Packet No. STN 50-470F

February 16, 1984  
LD-84-008

Subject: Comprehensive Vibration Assessment Program  
Reference: NUREG-0852, Safety Evaluation Report, dated November 1981  
Enclosure: Proprietary Affidavit for CEK-263(V)-R

REVISED FSAR CHAPTER 14.2

Figure 14.2-1

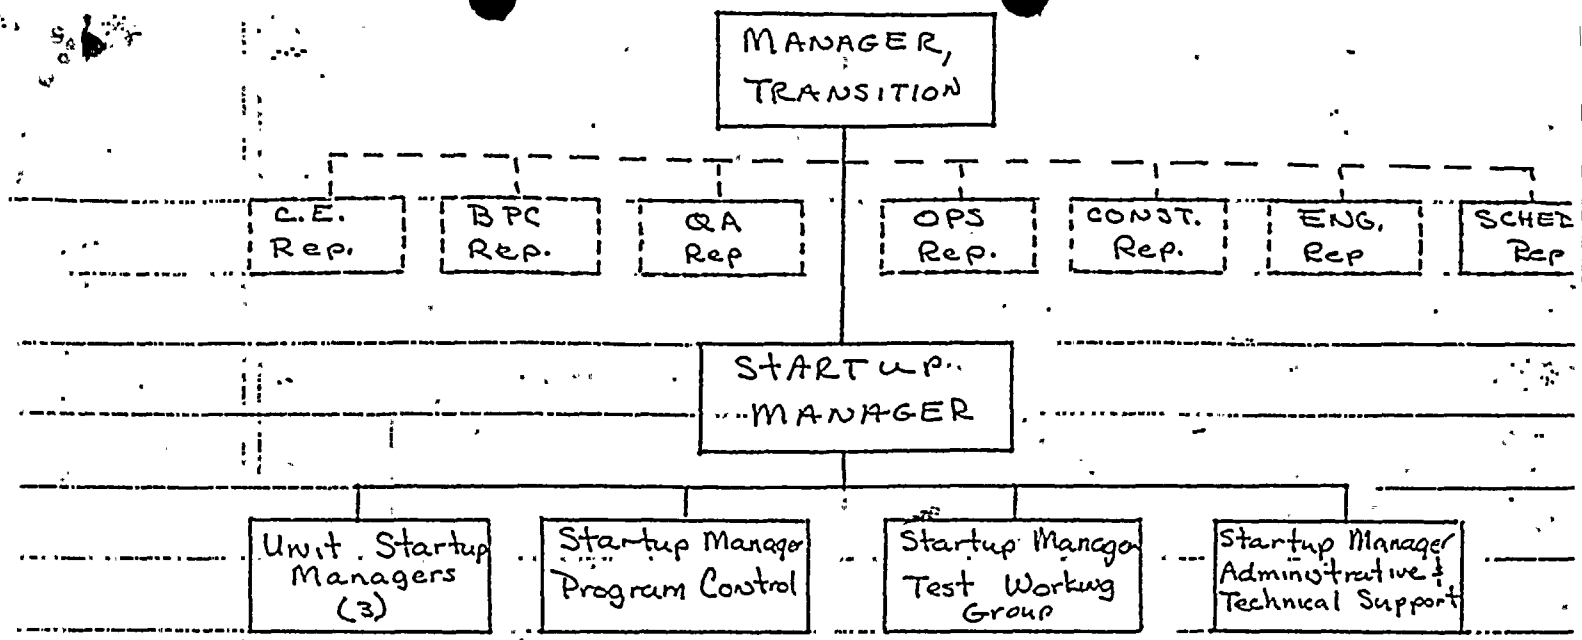
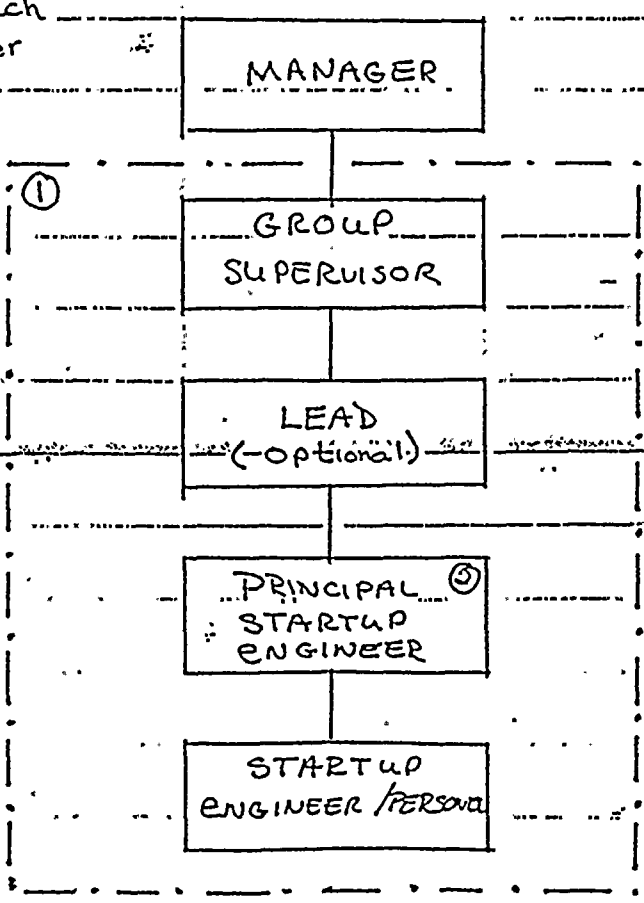
640.17 In the FSAR, Chapter 14 Table of figures, FSAR Figures 14.2-1 and 14.2-2 state that they will be provided later. Figure 14.2-1 is referenced in FSAR Subsection 14.2.2.11 (Organizational Responsibilities), while Figure 14.2-2 is not referenced in the current FSAR Chapter 14 submittal. The figures should be provided or deleted (Amendment 12 modification).

APS has recently undergone a realignment of the organization that resulted in additional revision to FSAR Chapter 14 since Amendment 12 was submitted. Attached is a marked up copy of FSAR Chapter 14.2 reflecting these changes. Figure 14.2-2 will be deleted from the text.

*SEE ATTACHED  
FIGURE 14.2-1*
